**FINAL TECHNICAL INTERCHANGE MEETING NO. 5 MEETING MINUTES
 PLANS FOR UPCOMING INVESTIGATIONS, SWMU B-3 BIOREACTOR STATUS UPDATE
 AND SITE MANAGEMENT PLAN OVERVIEW
 CAMP STANLEY STORAGE ACTIVITY, BOERNE, TEXAS
 FA8903-04-D-8675/DELIVERY ORDER 0006
 PARSONS 744223.01000**

Date: Friday, March 9, 2007
 Time: 9:00 A.M. - 2:00 P.M.
 Place: Camp Stanley Storage Activity (CSSA)
 Subject: SWMU B-3 Bioreactor Status, Upcoming Investigations, Site Management Plan
 Attendees:

Sampling Plan: AOC 63

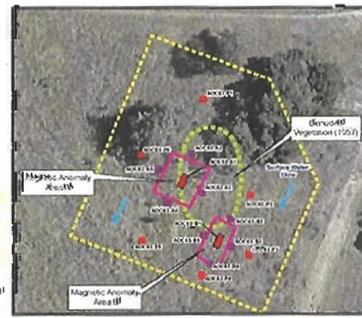
trenches are planned. Currently planned analyses include volatile organic compounds (VOC), semivolatile organic compounds (SVOC), metals and explosives. Mr. Chapa requested concurrence from TCEQ and USEPA to remove explosives from the planned sampling. No MEC has been observed at this site. There is no evidence that MEC is an issue at AOC 63. Additionally, Mr. Chapa noted that if the investigation of magnetic anomaly area B does not indicate that buried material is present, he does not plan to extend the trenching at that anomaly.

Greg Lyssy concurred that explosives are not necessary. Mr. Rayos and Ms. Power added that if MEC is visually located on site, then the TCEQ would like to make sure that explosives analyses would be performed. Mr. Chapa agreed that if MEC is located, then explosives analysis would be run. Mr. Lyssy also indicated that if explosives analyses are necessary, that EPA's preference would be for CSSA to use analytical method SW 8330B. He initially indicated that this analytical method should be used, but upon further discussion with Steve Mitchell, it was agreed that it would not be necessary at this stage of the investigation.

Sampling Plan: SWMU B-71

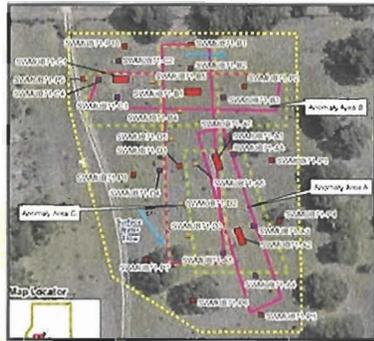
Mr. Chapa continued with a description of planned sampling at SWMU B-71. To investigate the anomaly areas at this site, Mr. Chapa requested concurrence of Weston's planned approach to potentially reduce the number of samples collected at each anomaly and move those samples to delineate other anomalies, if needed. Specifically, Mr. Chapa requested that if previously investigated anomalies show no evidence of waste disposal activities, that the investigation sampling would be shifted to those areas indicated by Weston's recently completed geophysical survey. TCEQ and USEPA both agreed with this approach.

Sampling Plan: AOC 64

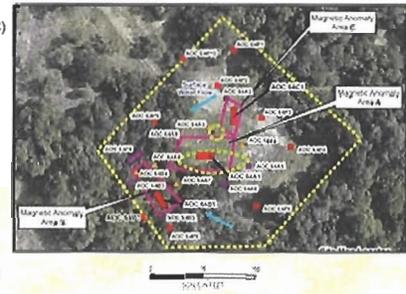
Mr. Chapa continued to discuss the plan for AOC 64, a site where he does expect to encounter rock near the surface. Exploratory trenching will be conducted at the three source area anomalies. At the drainage feature that was discussed earlier, he will place one trench across the drainage. Perchlorate analysis will be added for this site based on the spent flares observed. He has indicated that there appears to be an observed a large kickout area of debris from explosions.
